Date: December 15, 2003
 To: T10 Committee (SCSI)
 From: Jim Coomes (Seagate)
 Subject: SBC, SPC, Obsolete Third Party XOR Commands

This is a proposal to obsolete the third party XOR commands.

Figure 0.1 — Update write operation (third-party)

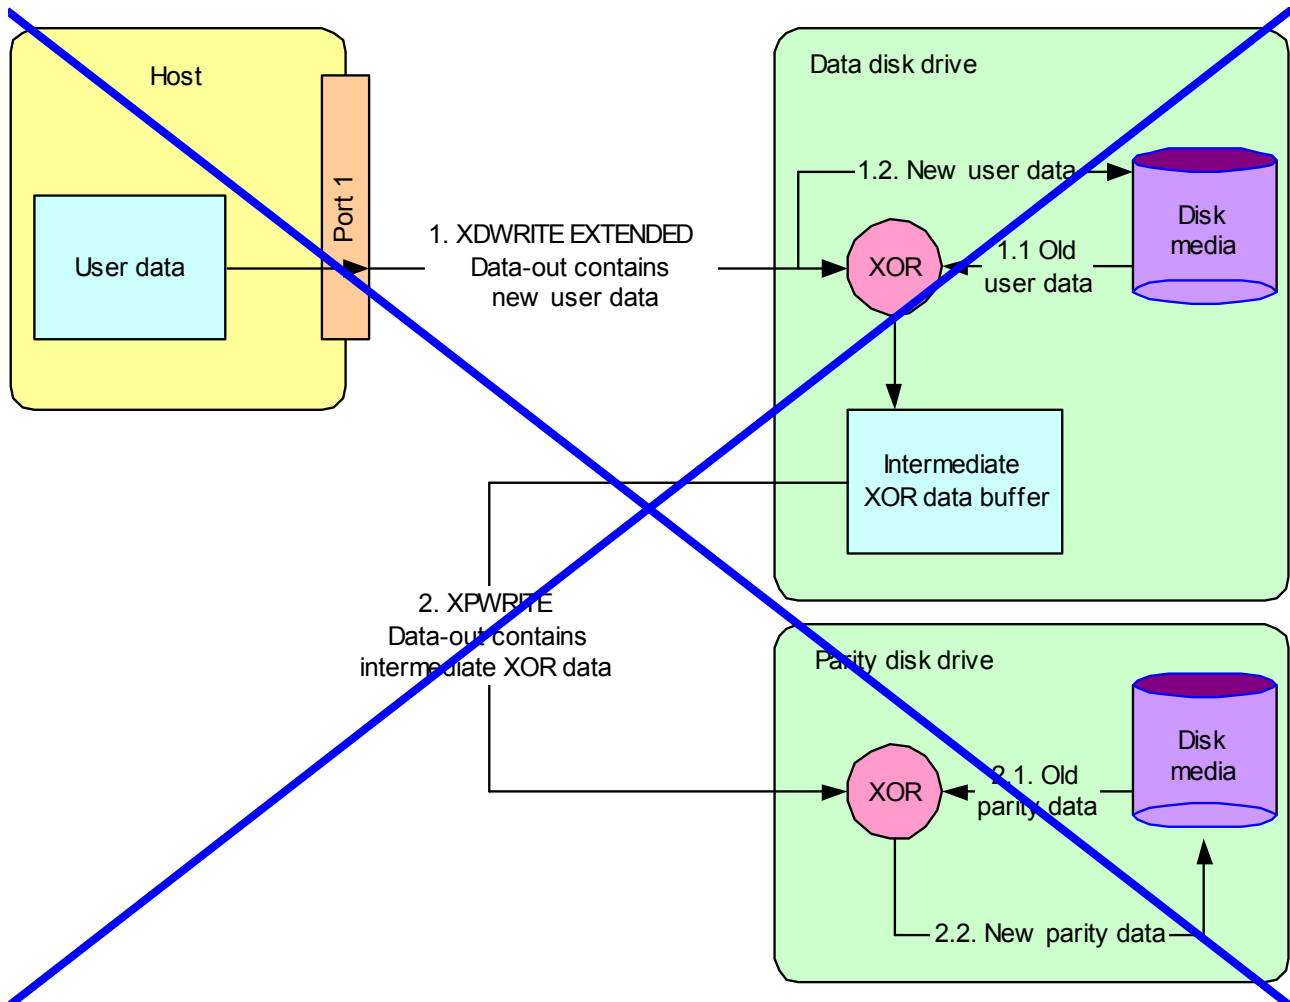
~~Figure 0.1 illustrates a third party read modify write operation. The example uses a host, a data disk device (holding protected user data), and a parity disk device (holding check data). In this example, the data and parity devices are on the same SCSI physical interconnect, and thus are capable of peer to peer interaction. Two SCSI commands are used: XDWRITE EXTENDED and XPWRITE.~~

Figure 0.2 — Regenerate operation (third party)

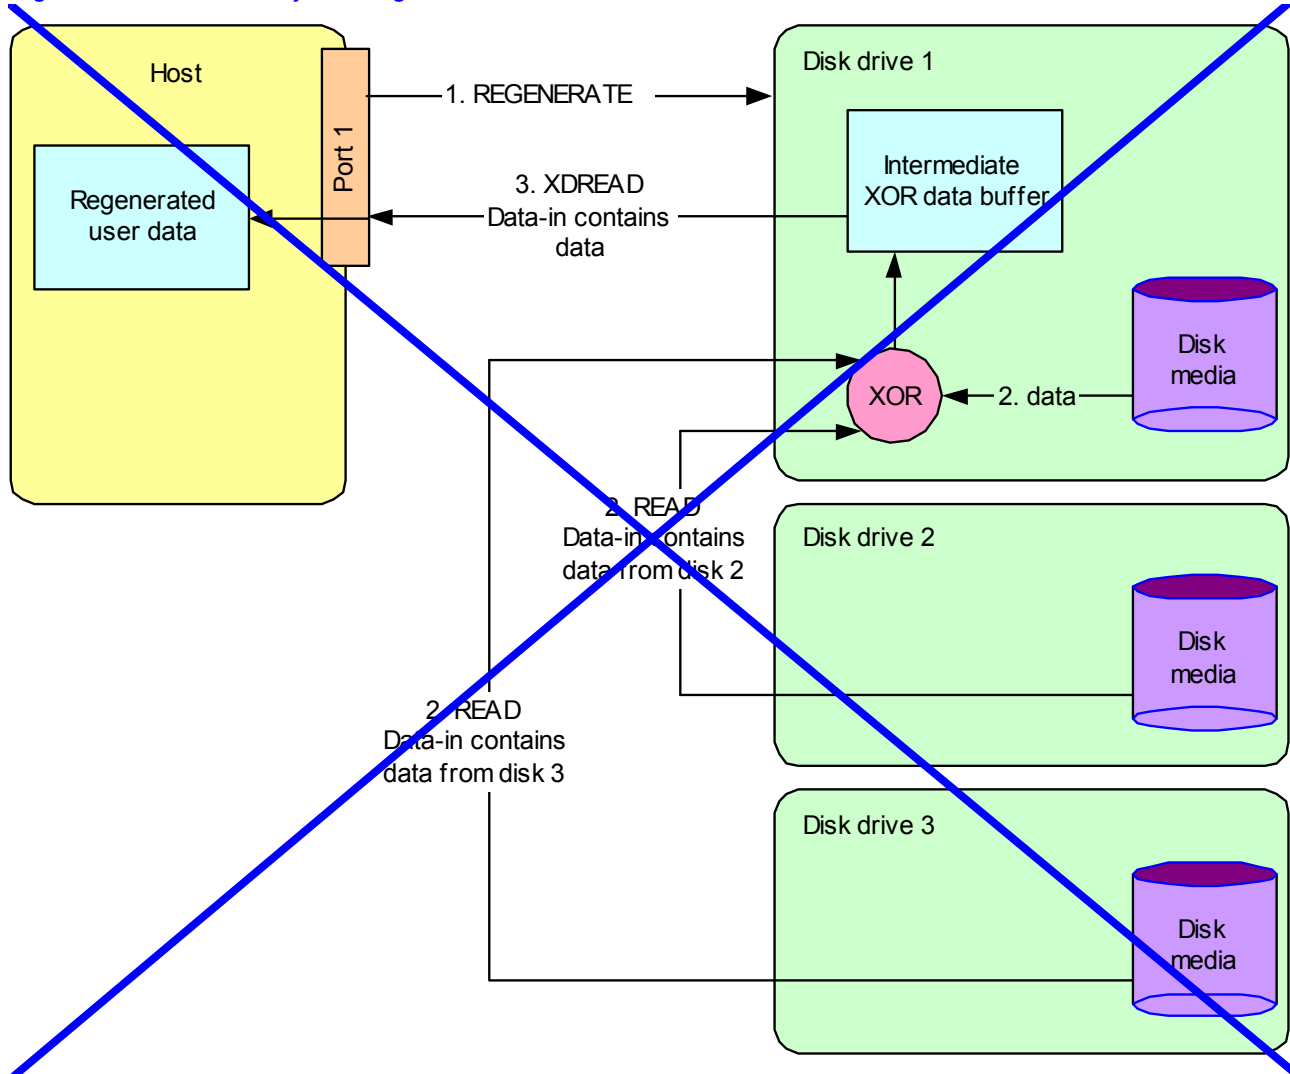
Figure 0.2 illustrates a third-party regenerate operation. The example uses a host and three disk devices. In this example, all three disk devices are on the same SCSI physical interconnect, and thus are capable of peer to peer interaction. Three SCSI commands are used: REGENERATE, READ, and XDREAD.

Figure 0.3 — Rebuild operation (third party)

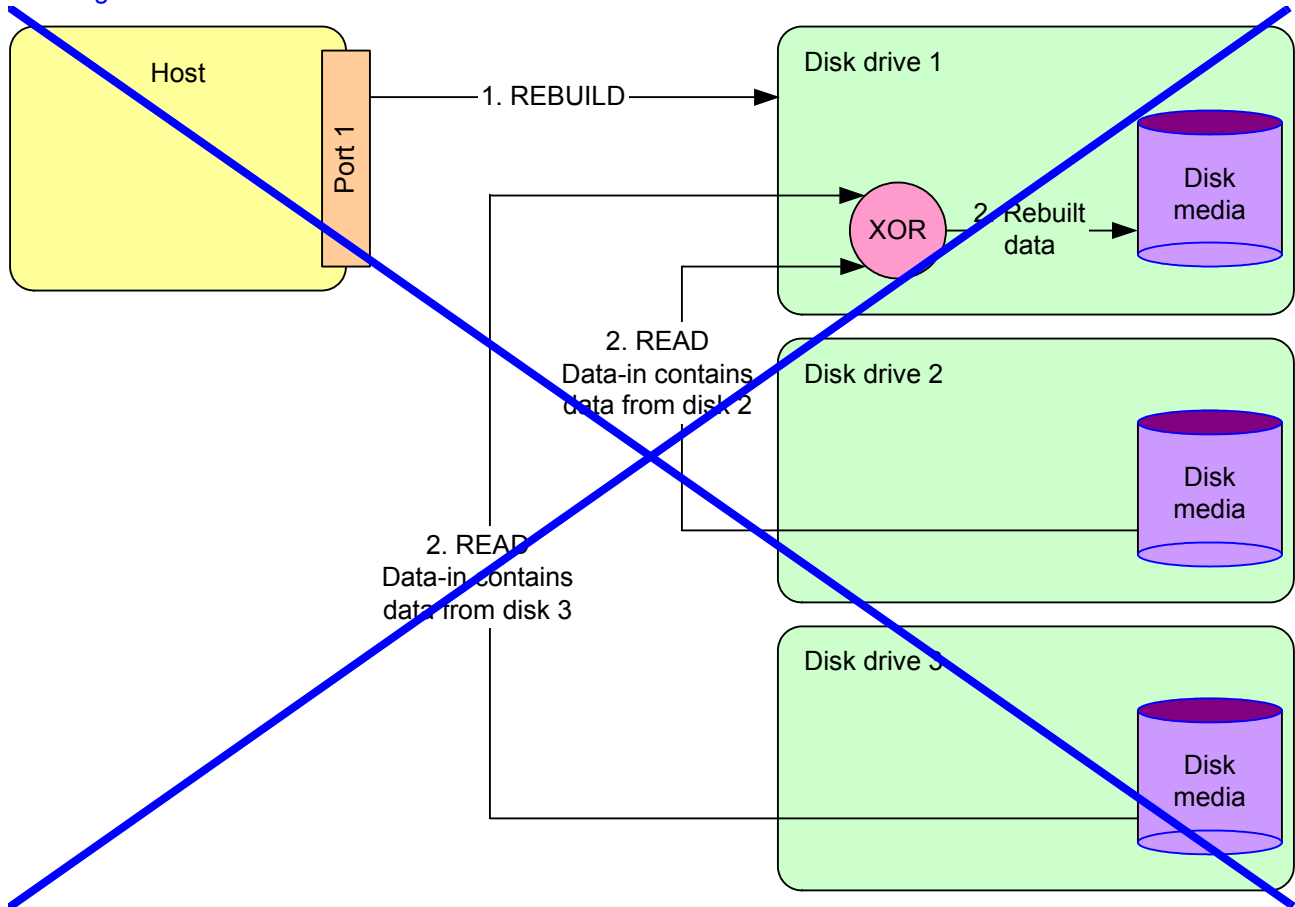
Figure 0.3 illustrates a third party rebuild operation. The example uses a host, two disk devices as the source devices, and one disk device as the device being rebuilt. In this example, all three disk devices are on the same SCSI physical interconnect, and thus are capable of peer-to-peer interaction. Two SCSI commands are used: REBUILD and READ.

Figure 0.4 — Regenerate operation (hybrid subsystem)

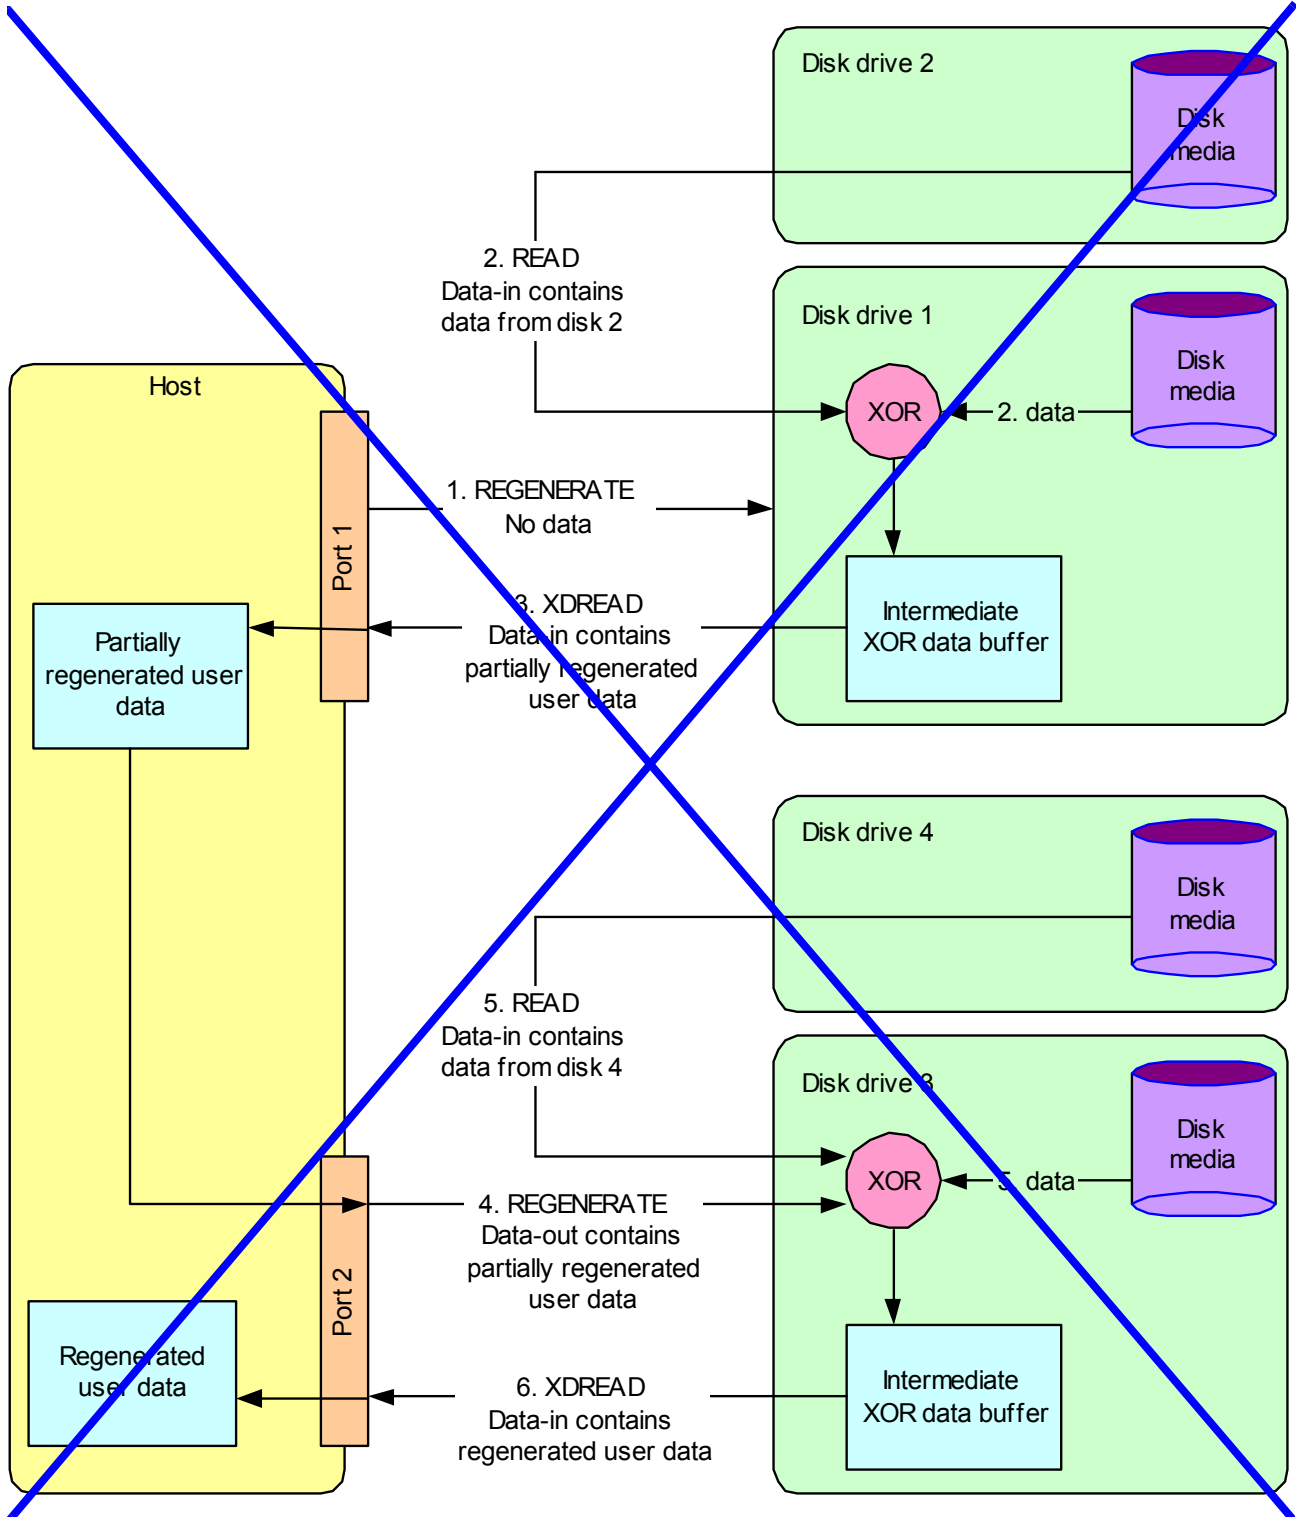
Figure 0.5 illustrates a regenerate operation on a hybrid system. The example uses a host and four disk devices as source devices. In this example, two of the disk devices are on one SCSI physical interconnect, and thus are capable of peer to peer interaction between themselves. The two other disk devices are on a different SCSI physical interconnect and are also capable of peer to peer interaction between themselves. Three SCSI commands are used: REGENERATE, READ, and XDREAD.

Figure 0.5 — Rebuild operation (hybrid subsystem)

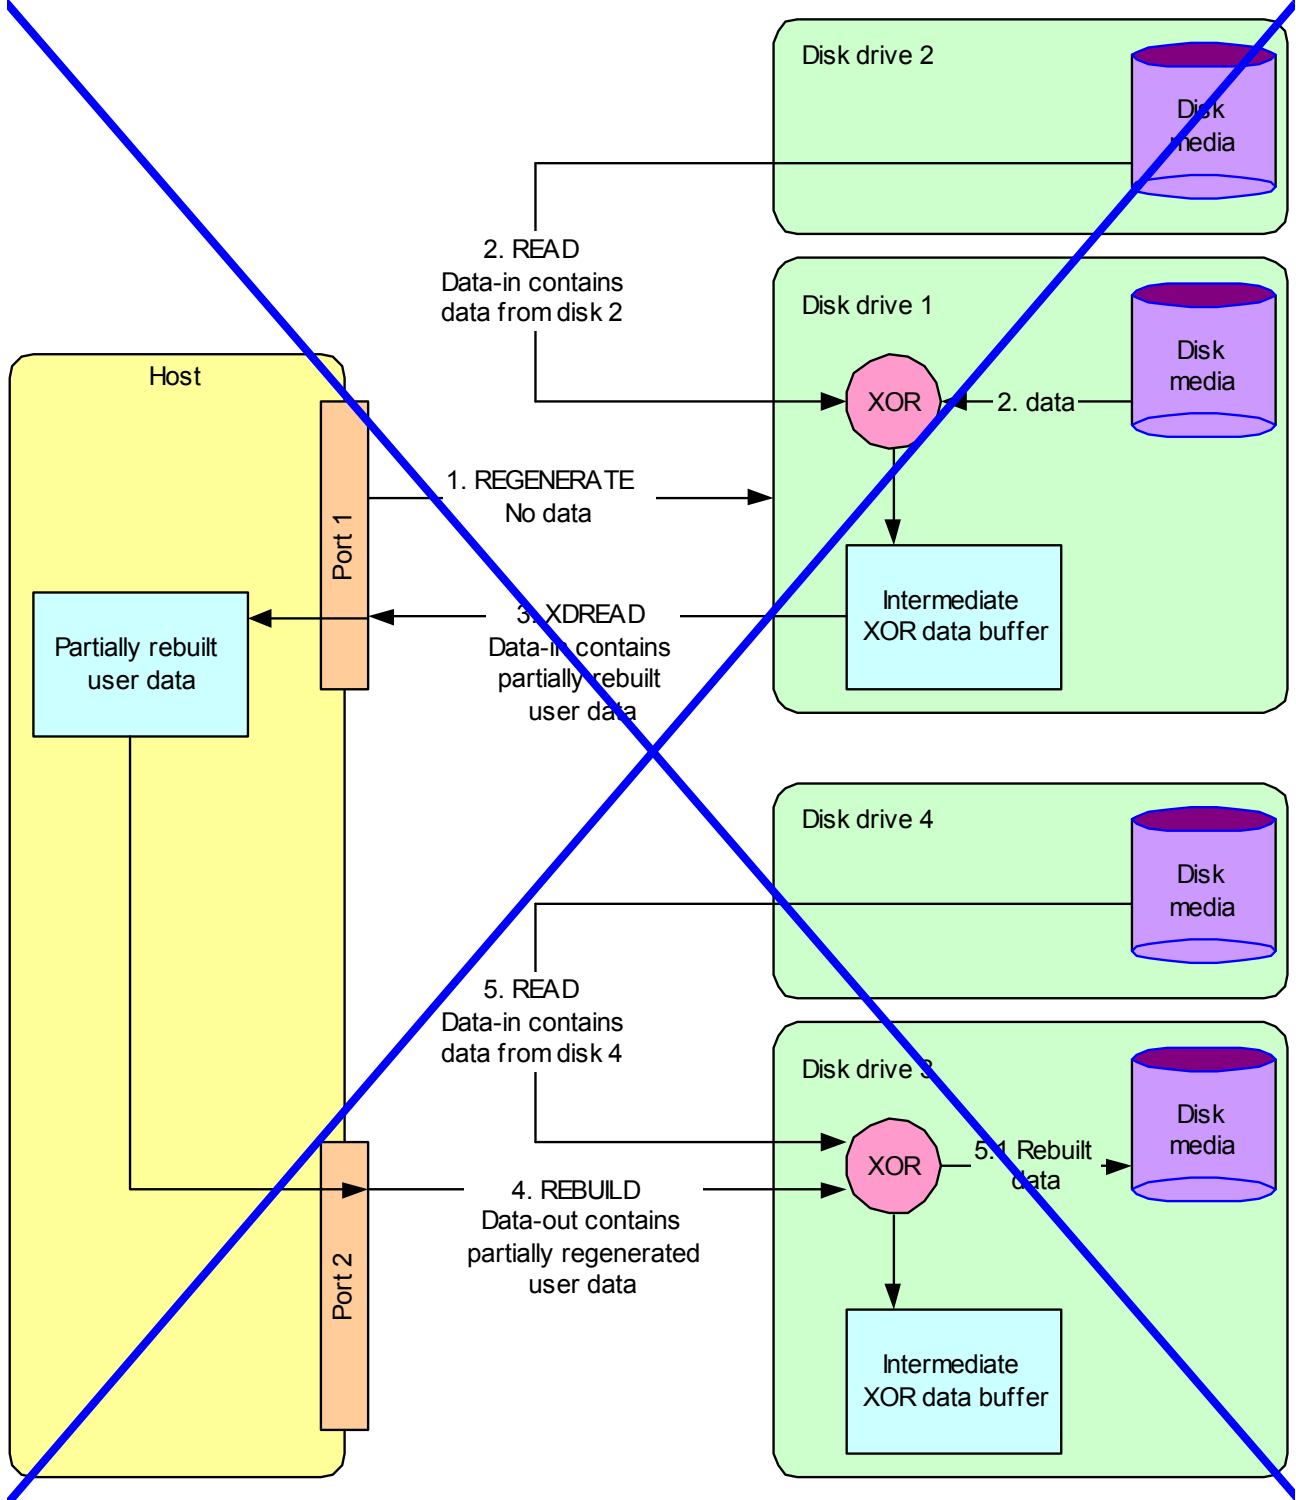
Figure 0.5 illustrates a rebuild operation on a hybrid system. In this example, two of the disk devices are on one SCSI physical interconnect, and thus are capable of peer to peer interaction between themselves. The two other disk devices are on a different SCSI physical interconnect and are also capable of peer to peer
